City of Portland Design Commission

Design Advice Request

SUMMARY MEMO

Date: 2/14/2022
To: Maurice Robb, Access Architecture
From: Tanya Paglia, Design Review
Tanya.Paglia@portlandoregon.gov | 503-865-6518
Re: EA 21-107671 DA – 9919 NE Glisan St | Glisan Tower
Design Advice Request Commission Summary Memo – 1/13/2022

NW CORNER - NE 99TH AVE

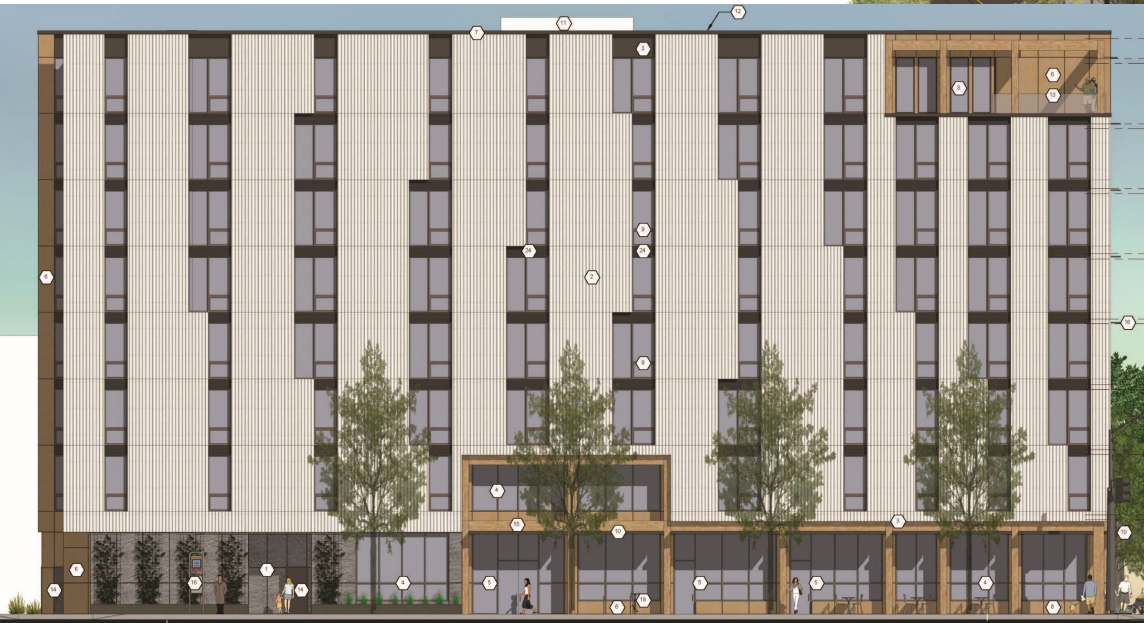
Topic #2 – Unified Base:

- Shift in materials and change to planters detracting from coherency
- Simpler base needed given interesting and complex expression of the building above

MAIN RESIDENTIAL ENTRY - NE 99TH AVE

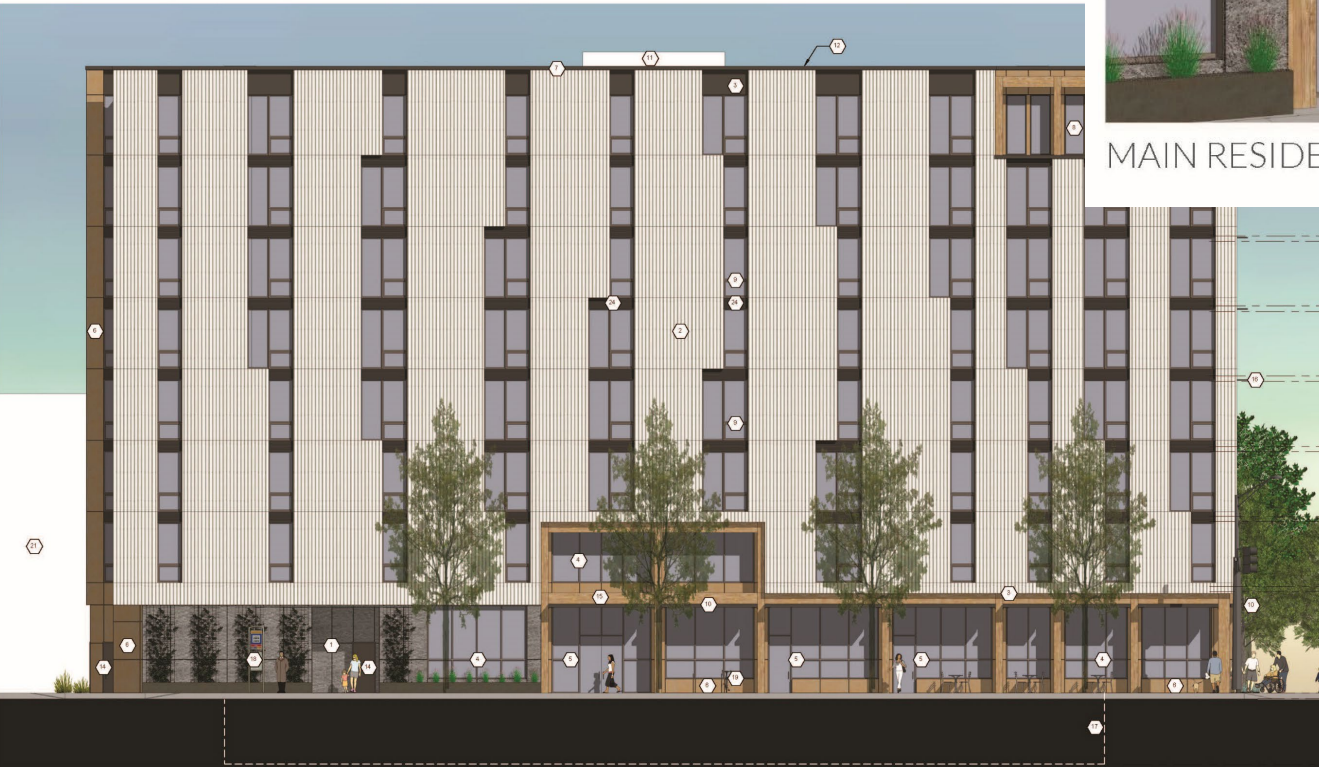
Topic #3 – Main Entrance:

- Double-height main entrance visually centered on the west elevation creates a symmetrical base that clashes with the highly asymmetrical building above
